TENNESSEE VALLEY AUTHORITY (TVA)
SEQUOYAH NUCLEAR PLANT (SQN)
UNIT 2

RESPONSE TO REQUEST FOR ADDITIONAL INFORMATION REGARDING
STEAM GENERATOR REPORTS FROM CYCLE 13 REFUELING OUTAGE

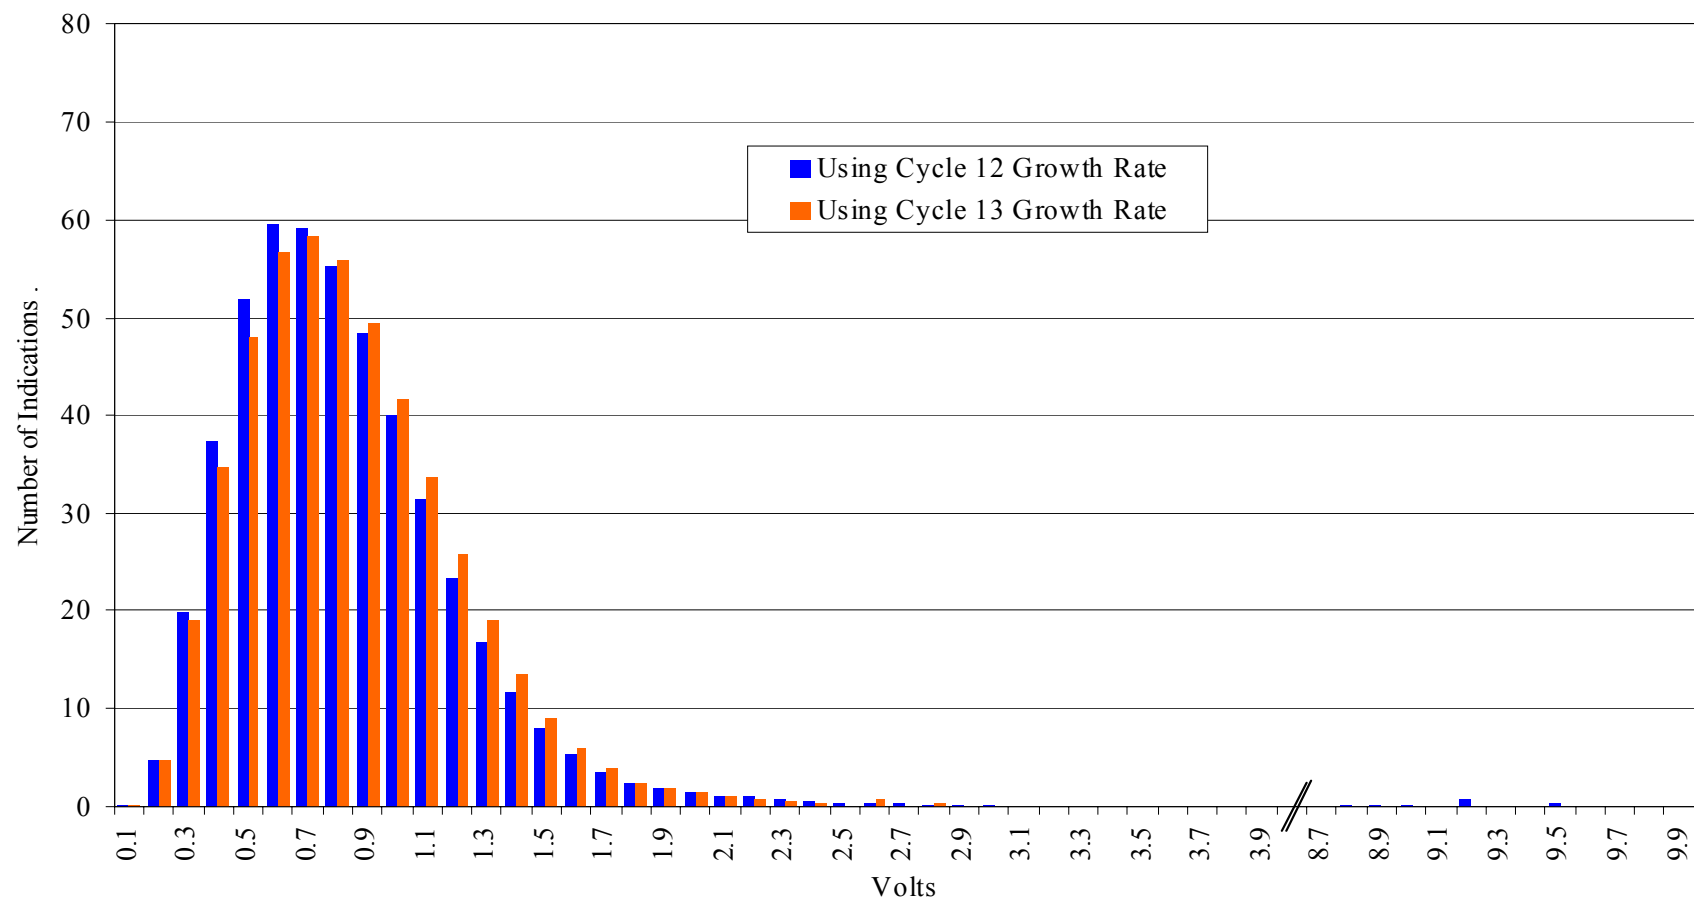
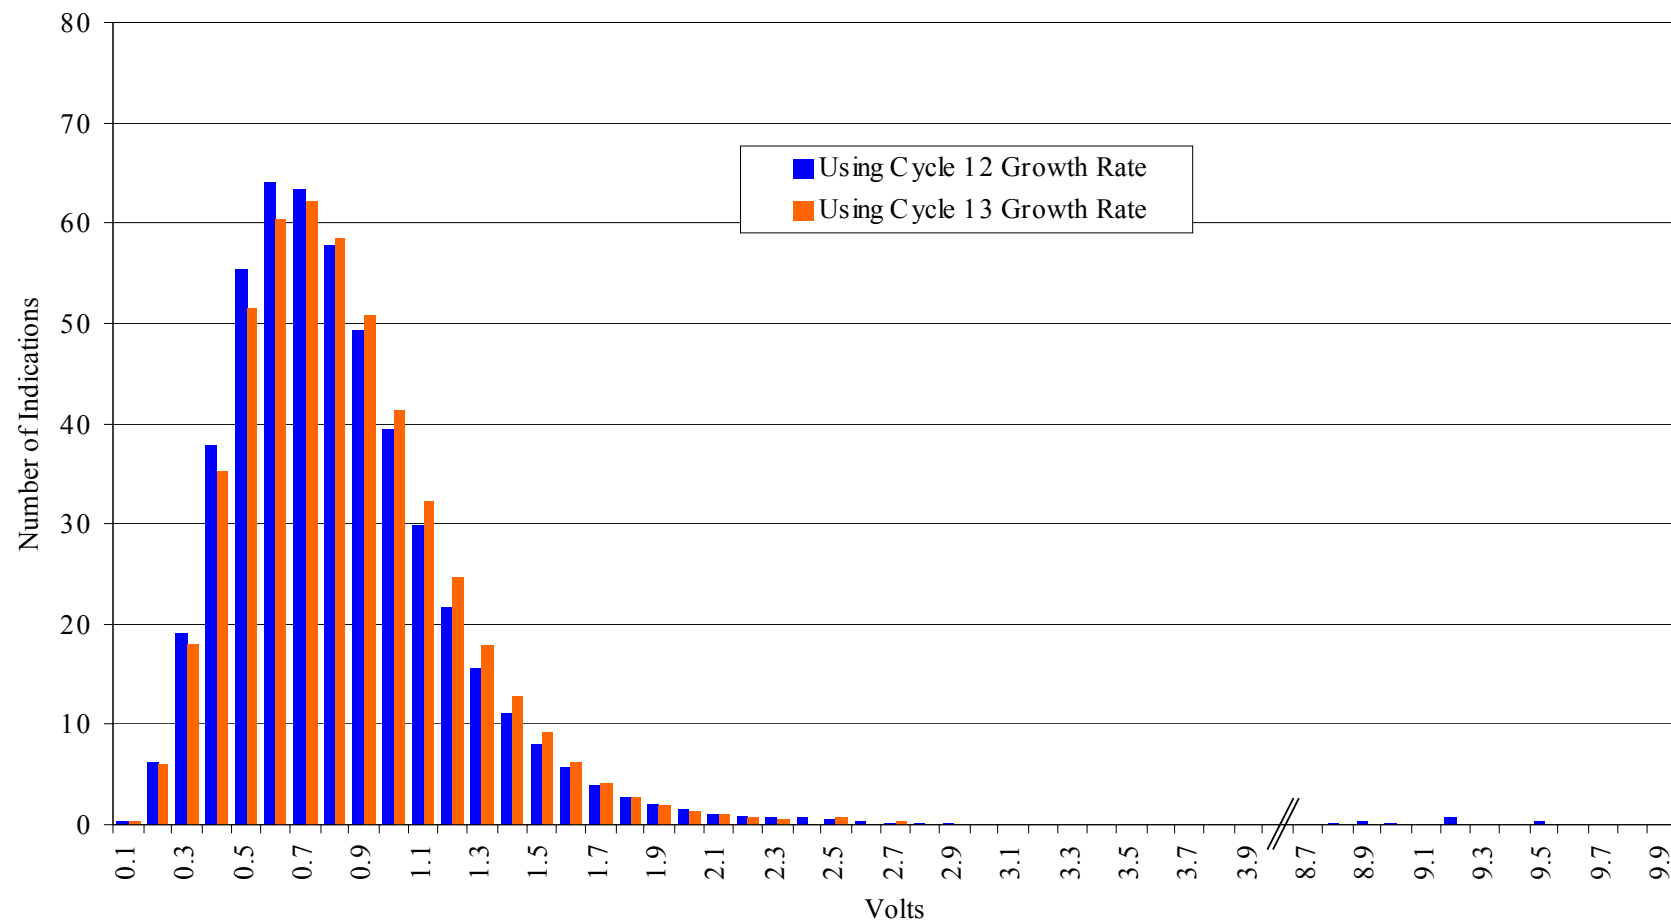
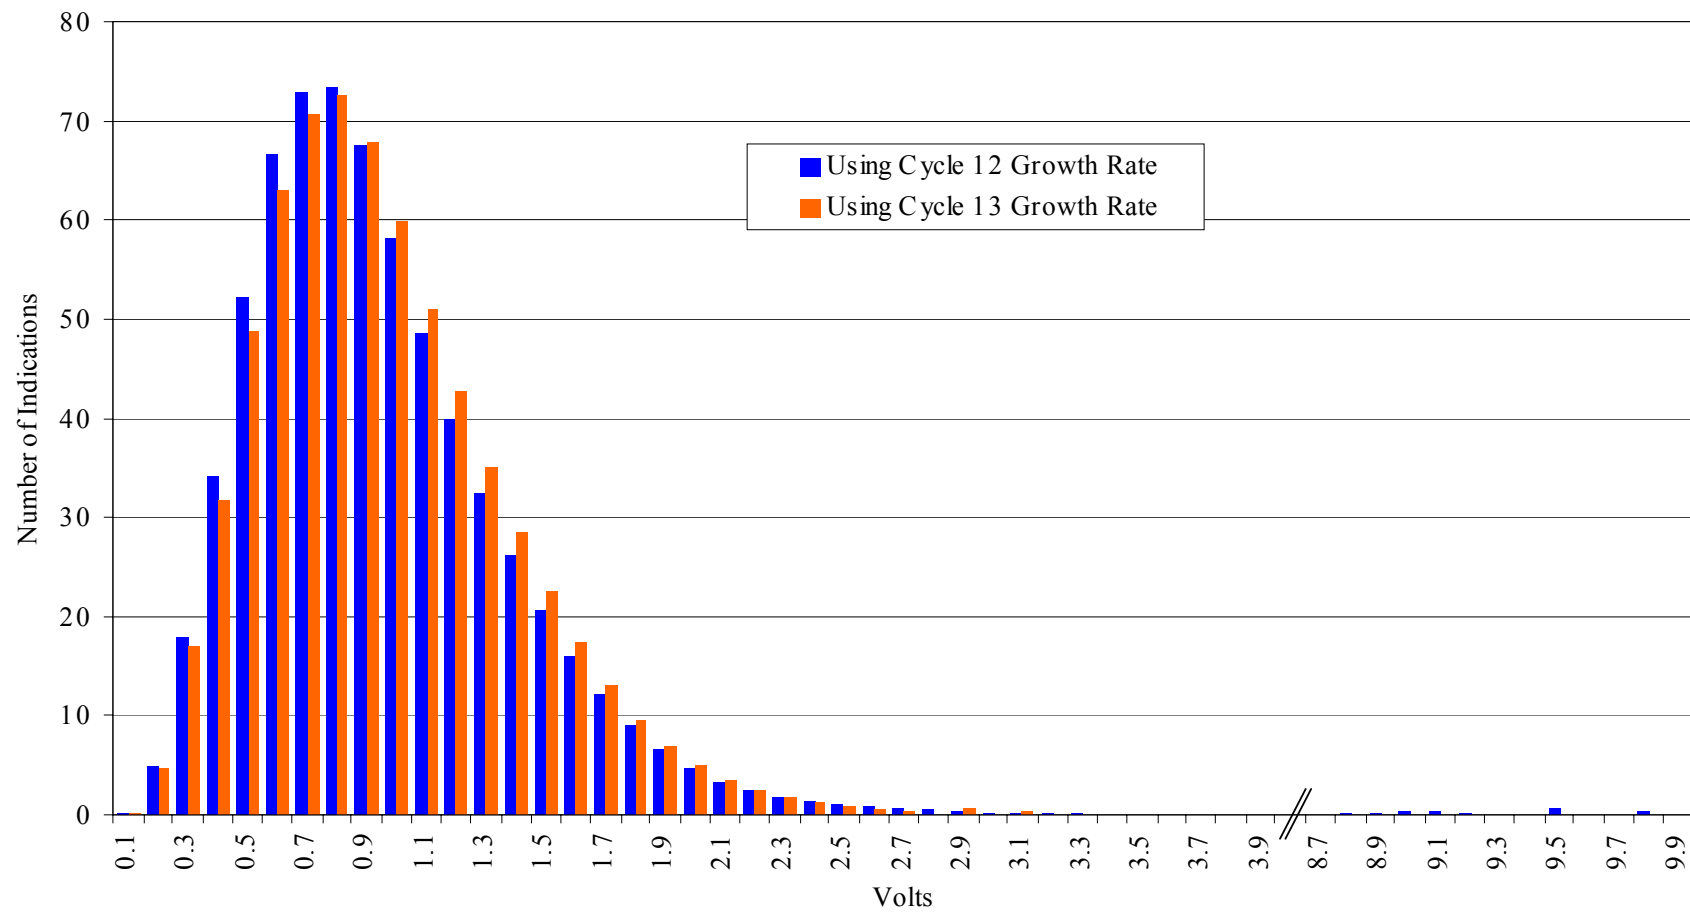
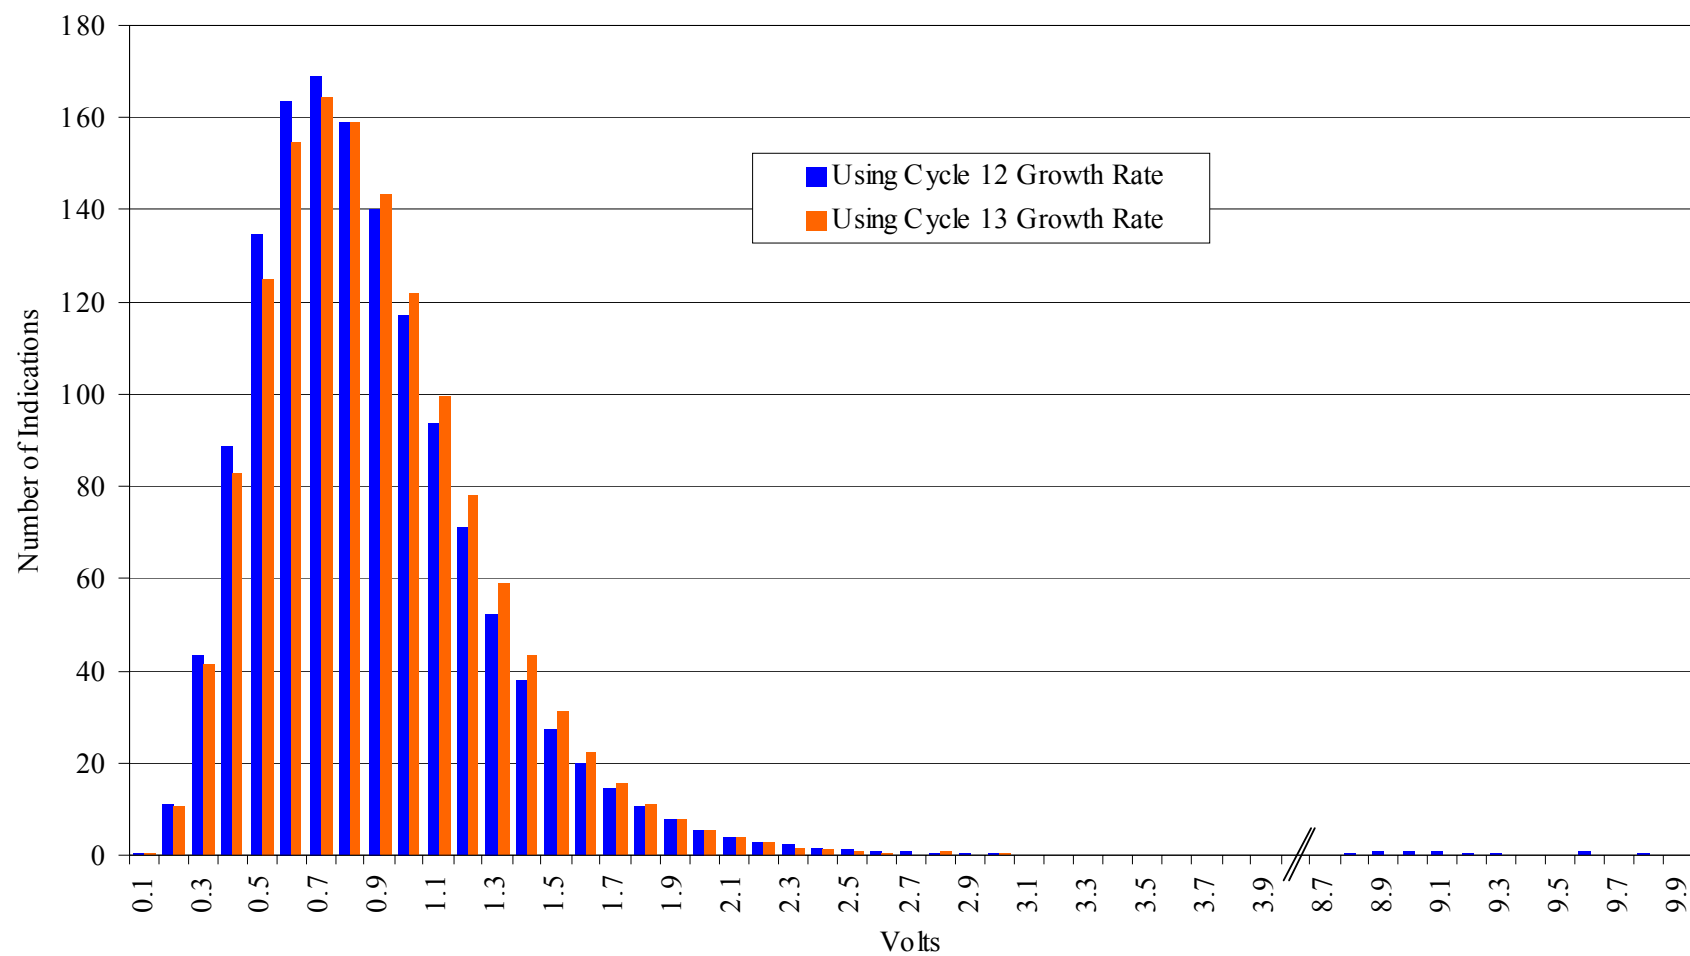
In Section 6.4 of Enclosure 1 to your August 15, 2005, letter, it was indicated that the EOC 14 voltage distribution (using both the Cycle 12 and Cycle 13 growth rates) are shown in Table 6-2 and in Figures 6-1 through Figure 6-4. In reviewing the table and figures only one voltage distribution was provided for each steam generator.

Please clarify whether the tables and graphs provided were determined using the Cycle 12 or Cycle 13 voltage growth rate distribution.

In addition, Section 6.4 indicates that the voltage distributions predicted using both growth rates are similar, however, the predictions using the Cycle 13 growth rates were populated with somewhat greater frequency in the lower voltages and with higher tail-end voltages. Since the most limiting voltage growth rate distribution is the one that results in the highest projected probability of burst and leakage, discuss how it was determined that the Cycle 12 growth rate distribution was the most limiting. The staff notes that sometimes the higher tail end voltages can result in more limiting probability of burst or leakage estimates (i.e., the largest voltage indication may have a significant effect on the leakage and burst calculations depending on the distribution of indications).

The Cycle 12 growth rate clearly has a longer upper tail due to the inclusion of the one large voltage indication found at EOC-12. Only the results using the Cycle 12 growth rate were included in the EOC-13 90 Day Report (Westinghouse Report SG-SGDA-05-29, Rev.0) since this did produce the more conservative results. The Table 6-2 and Figures 6-1 to 6-4 and Table 6-3 all are results using the Cycle 12 growth rate.

The reference to using both growth rates is an editorial error. The statement "voltage distributions predicted using both growth rates are similar, however, the predictions using the Cycle 13 growth rates were populated with somewhat greater frequency in the lower voltages and with higher tail-end voltages" is also an editorial error.

In order to demonstrate that the Cycle 12 growth rate results in the more conservative predictions the predictive results of using both the Cycle 12 and Cycle 13 growth rates are presented here. The analyses clearly indicate that the Cycle 12 growth rate results are more conservative. Therefore, the results in the report are correct.
